# UNITED STATES PATENT AND TRADEMARK OFFICE

APPLICATION NO.	FILING DATE	FIRST NAMED INVENTOR	ATTORNEY DOCKET NO.	CONFIRMATION NO.
10/748,857	12/30/2003	Randall Cornfield	ICS-handle	6240
7590	03/03/2009	DAN M. DE LA ROSA, Esq. 300 EAST 77th STREET, SUITE 24C NEW YORK, NY 10075	EXAMINER WILLIAMS, MARK A	
			ART UNIT 3673	PAPER NUMBER
			MAIL DATE 03/03/2009	DELIVERY MODE PAPER

<b>Office Action Summary</b>	<b>Application No.</b>	<b>Applicant(s)</b>
	10/748,857	CORNFIELD, RANDALL
	<b>Examiner</b>	<b>Art Unit</b>
	MARK A. WILLIAMS	3673

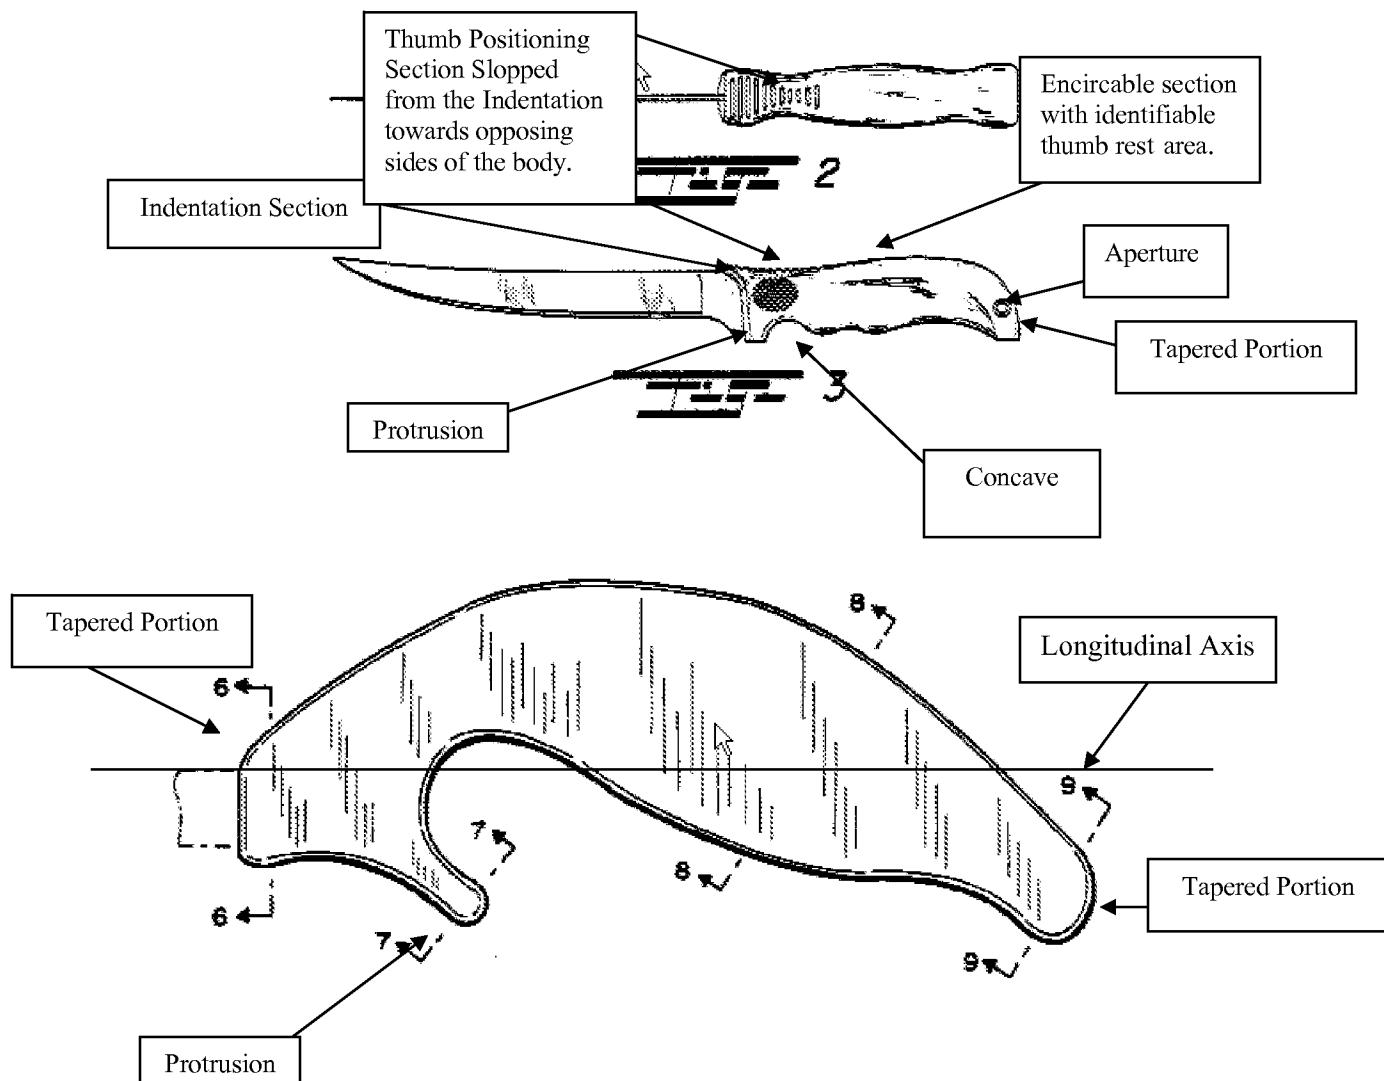
Herron provides a handle implement comprising an elongated body having a front side and a tapered rear end, top and bottom surfaces and opposing sides, said body being generally rounded and being generally parallel to a longitudinal axis at the center of said body, as best understood, said tapered front side and said tapered rear end are situated on said axis at the center of said body; a thumb positioning section situated on said top surface of said body adjacent to said front side of said body, said thumb positioning section comprising a concave indentation, said thumb positioning section sloping downwardly from said indentation towards said opposing sides of said body, said thumb positioning section comprising a thumb rest section; and an index finger rest section situated on said bottom surface of said body adjacent to said front side of said body, said index finger rest section comprising a cavity with an extended protrusion, said protrusion designed to cover at least a portion of user's index finger. An encirclable section situated adjacent said rear end of said body, said section being generally rounded in its circumference. The encirclable section is designed to support user's palms and three fingers. The thumb positioning section is situated above said index finger

Regarding (1)-(3), Mosley teaches these general concepts in a particular handle design. Such a design creates a particular visual appearance that may be desired. In addition, one skilled in the art would know that the particular indentation shape provides additional shielding to the finger of a user. It would have been obvious to include such modifications in the design of Herron for the

purpose of achieving a particular visual appearance of the handle as well as additional shielding means for a user's finger during use of the knife.

Applicant argues that Herron does not provide a thumb positioning section with a concave indentation and the thumb positioning section sloping downwardly from the indentation towards the opposing side of the body. The examiner disagrees, since such limitations can be read into the figure of Herron. See above attached figure. Looking closely at both figures 2 and 3, Herron can be interpreted to provide at least a minimum amount of sloping from the thumb position section to opposing sides of the body (note the lines in the drawings used to represent curved regions, as conventional in mechanical drawings and the like). Applicant has not sufficiently amended the claims to overcome the applied art of record.
